Administrative Application For Non-Standard Gas Well Location Chevron USA Production Co. G. C. Matthews #12 Surface Loc. 330' FSL & 990' FEL Section 6, T20S, R37E Monument Tubb West Pool Lea County, New Mexico

Re: Application for administrative approval for Chevron U.S.A. Production Company's existing G. C. Matthews Well No. 12 (API No. 30-025-05953) located 330' FSL & 990' FEL (Unit P) of Section 6, Township 20 South, Range 37 East, NMPM, Lea County, New Mexico, to be deepened to the Undesignated West Monument-Tubb Gas Pool and completed at the above-described unorthodox gas well location within the SE/4 of Section 6, being a standard 160-acre gas spacing and proration unit for this pool.

#### WELL NAME: G. C. Matthews #12

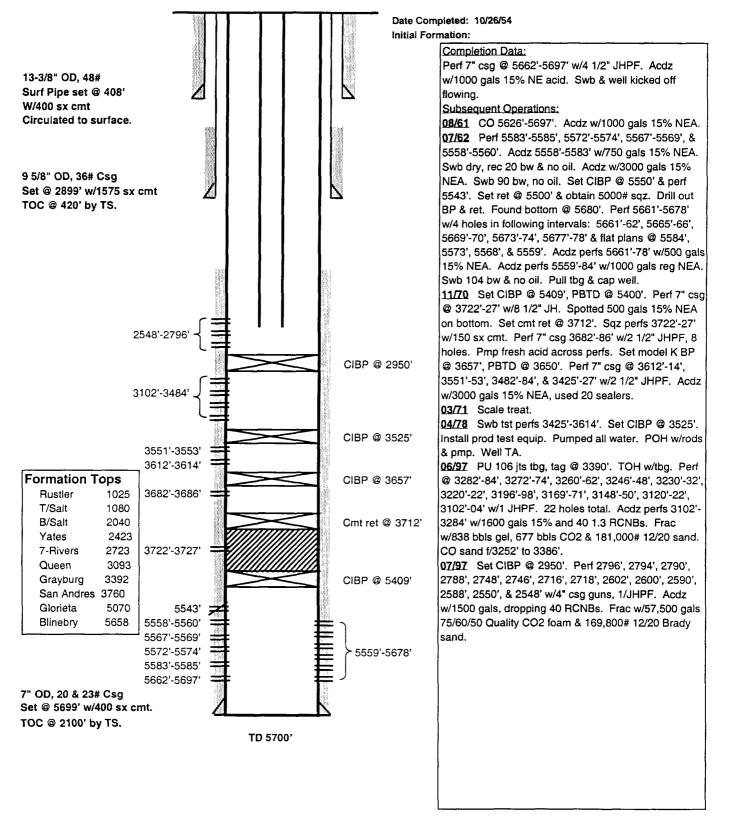
In reviewing the subject application I can't help but notice the availability of several other Chevron owned wells within the SE/4 of Section 6 located at standard gas well locations that could be deepened or others that would require a recompletion to add the Tubb interval. Why was this well chosen?

standard location at 1650' FSL and 2310' FEL. Well #7 has 5 <sup>1</sup>/<sub>2</sub>" casing and is a non-standard location at 990' FSL and 330' FEL. Well #9 has 5 <sup>1</sup>/<sub>2</sub>" casing at 5250' and is at a standard location, 660' FSL and 1650' FEL. Well #1 has 7" casing at 3714' and would have to be deepened about 2600' and is a standard location at 660' FSL and 1980' FEL. Well #12 has 7" casing at 5700' and would have to be deepened about 800' and is at a non-standard location.

Summarizing the details above, the P&A'd wells and the wells with 4  $\frac{1}{2}$ " casing or liners were not considered to be viable candidates, so wells #3, 4, 8, 11, 5, and 2 were put aside. Of the wells with 5  $\frac{1}{2}$ " and 7" casing, the 7" casing is the preferred size as it allows us to run 4  $\frac{1}{2}$ " casing as opposed to 3  $\frac{1}{2}$ " casing. The increased casing size allows us to run more conventional tools in the well for completion. The cost to drill a 4  $\frac{1}{2}$ " hole as compared to a 6 1/8" hole would be increased as we estimate an additional 4-5 days to drill to TD with the smaller hole. This makes wells #1, 10, and 12 the most desirable candidates. Of these three, well #12 was decided upon. Well #10 was in a nonfavorable location based upon the results of well #6, and #1 required an additional 1800' of hole to be drilled, which was estimated to take an additional 4-5 days and cost an additional \$30,000 - \$40,000. Well #12 also allows Chevron to protect the reserves on our lease from being drained by a well 330' from the lease line in a non-standard 160 acre standup proration unit.
